GROUT TREATMENT FACILITY DANGEROUS WASTE PERMIT APPLICATION UNIT MANAGERS MEETING - SPECIAL SESSION

DATE: August 1, 1990
LOCATION: Richland, Washington

A Grout Treatment Facility (GTF) meeting was held to discuss Ecology's Notice of Deficiency (NOD) dated June 19, 1990, comments 68 (thermocouple installation) and 326 (need for geotextile layer). These two comments were discussed at the last Unit Managers Meeting held July 26, 1990, in Lacey, Washington; however, based upon the discussion concerning comment 326, construction on GTF Vaults 102 and 103 would need to stop pending the installation of a geotextile membrane between the catch basin HDPE liner and the diffusion gravel.

THERMOCOUPLE TREE LOCATIONS FOR GROUT DISPOSAL VAULTS

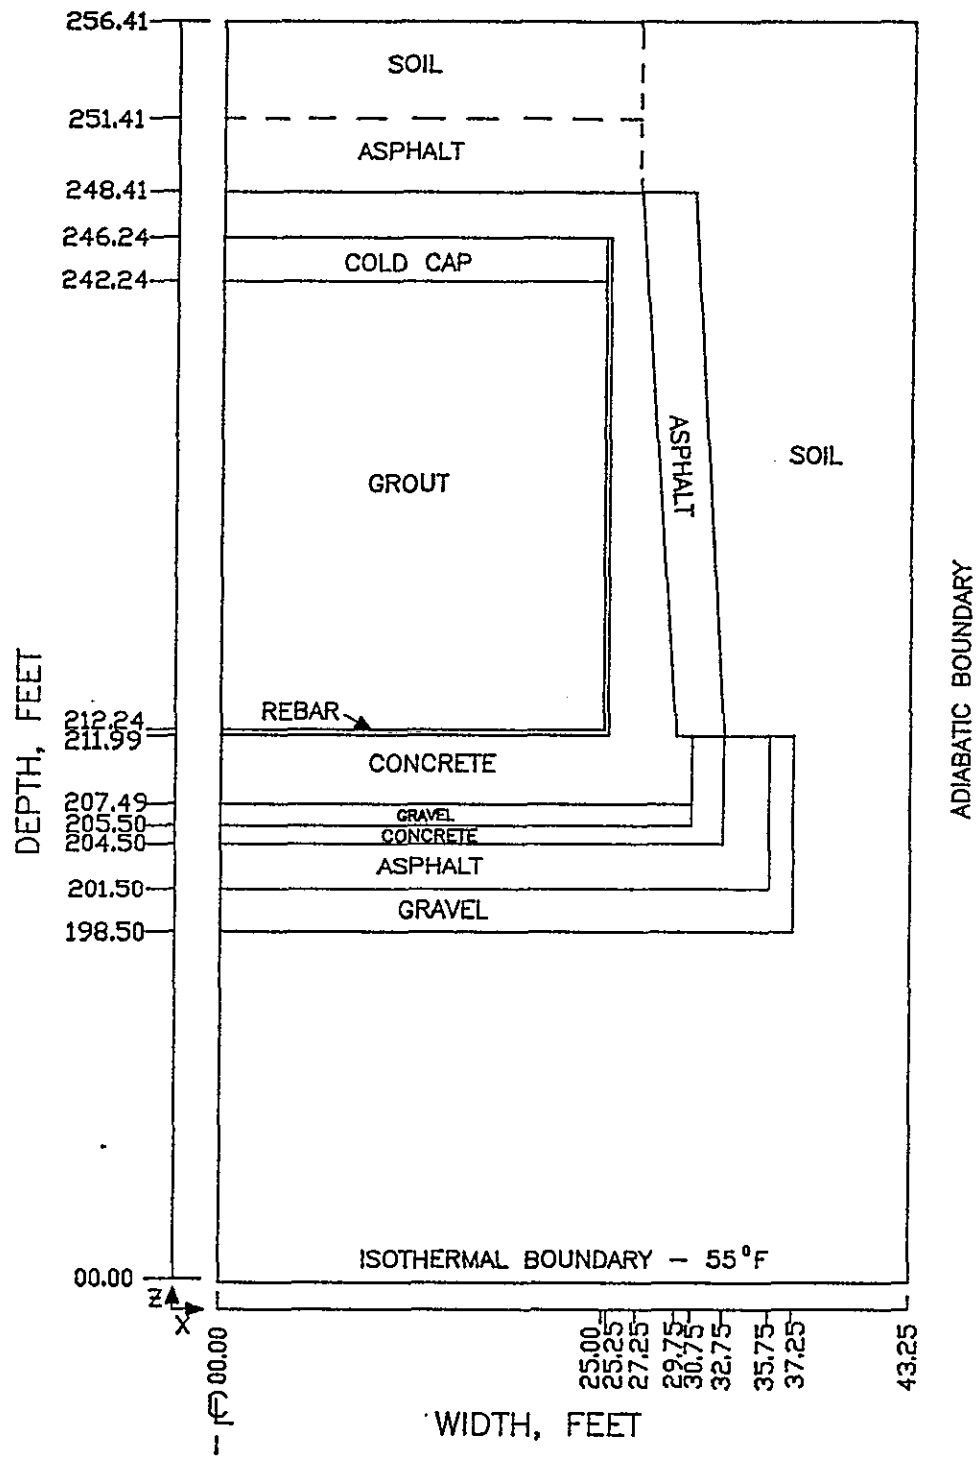
In order to obtain actual temperature measurements of the grout vaults, thermocouple trees would be installed in the following locations:

- Center of the vault
- Mid-way along the longest length sidewall, both inside and outside of the wall
- Mid-way along the shortest length sidewall, both inside and outside of the wall
- In the corner of the vault, both inside and outside of the corner.

Ecology and B&C tentatively concurred with the recommendations by DOE-RL/WHC for monitoring the temperature profiles within the GTF Vaults.

Maximum Grout Temperatures, 2-Dimensional Model

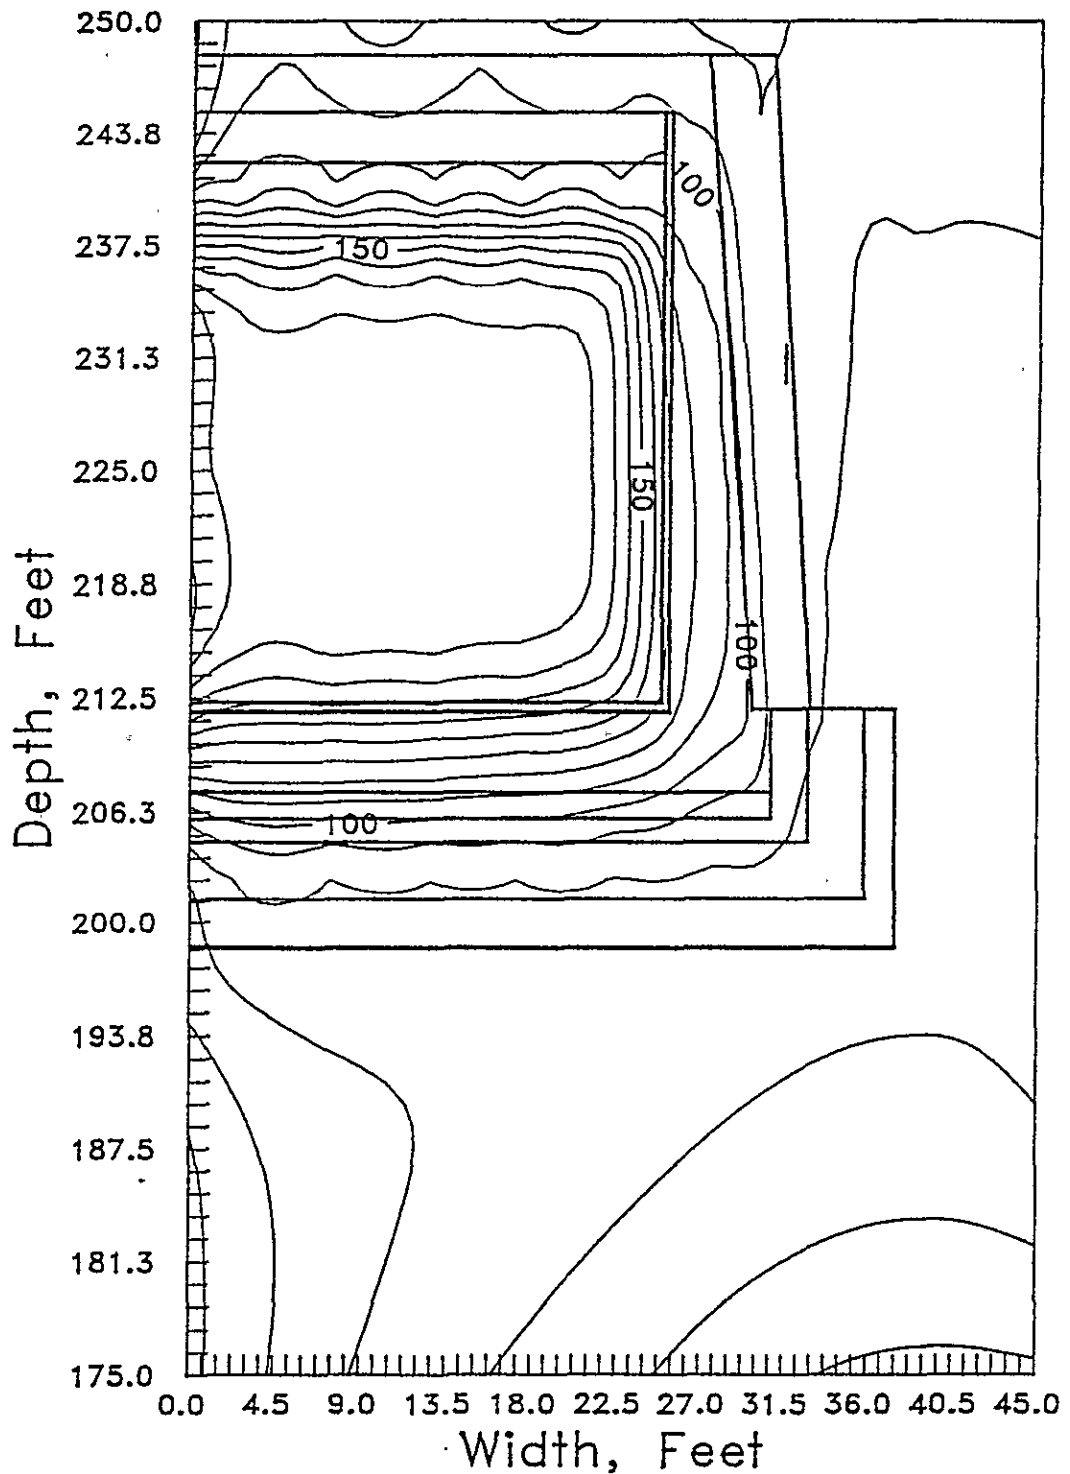
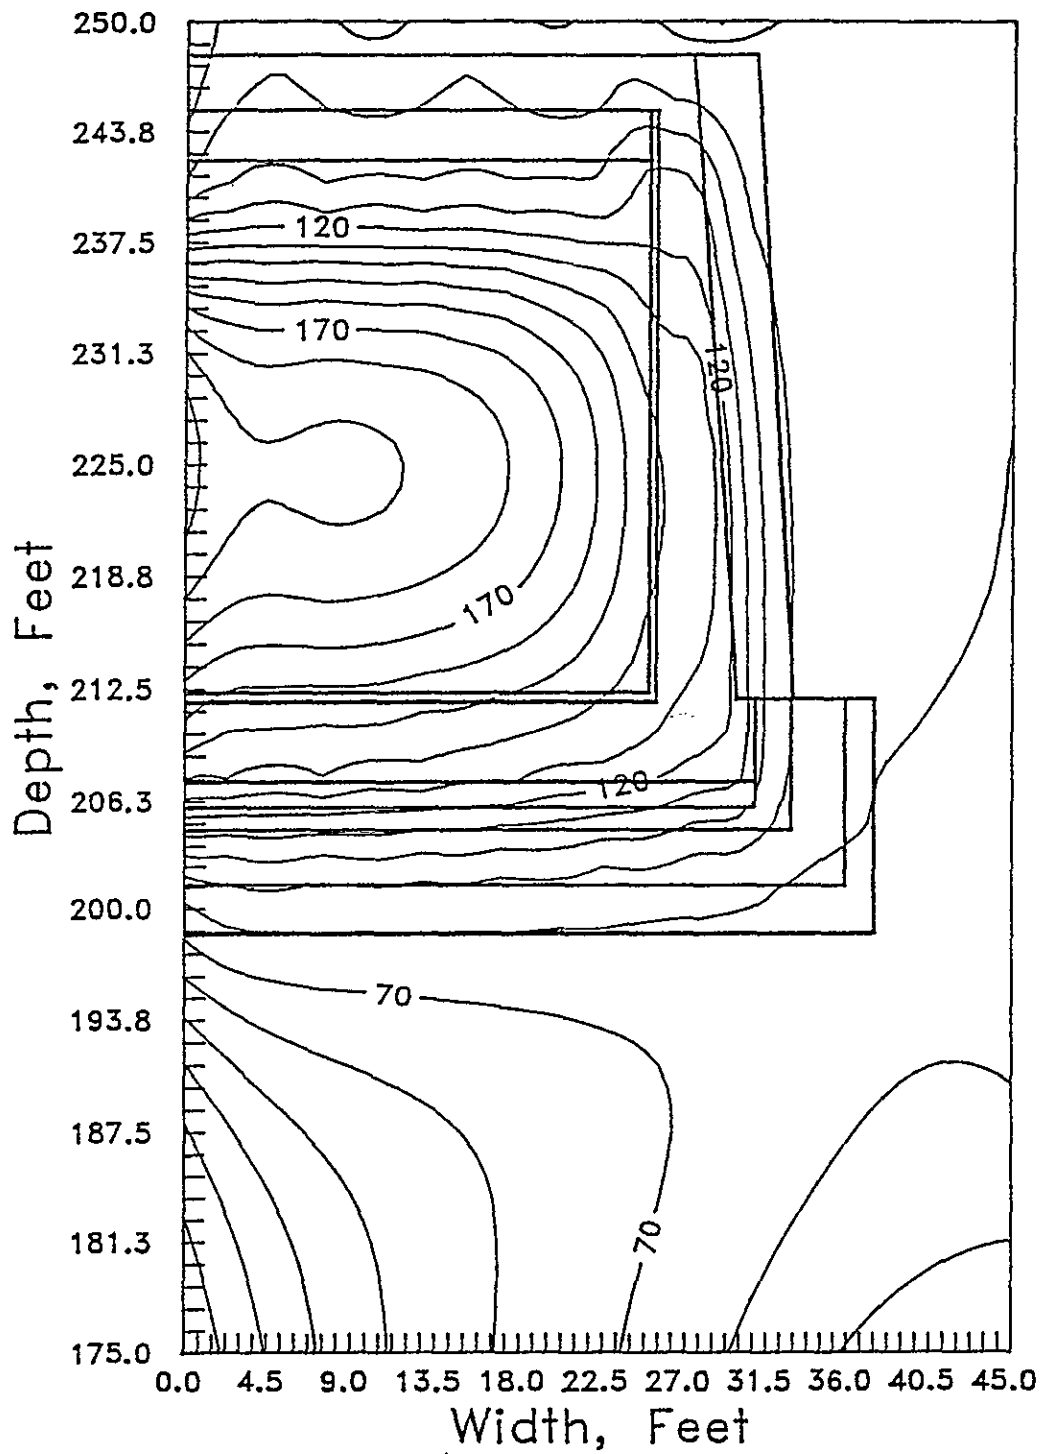
The presentation contained several graphs showing expected temperature profiles within the grout vaults after initial fill and three months after filling. This was done by using two dimensional numerical analysis techniques. A plot was made showing the predicted maximum temperatures within the vault comparing two dimensional with three dimensional analysis. The results showed that the two methods predicted nearly identical temperatures in the first year with the two dimensional analysis predicting higher temperatures after this time.
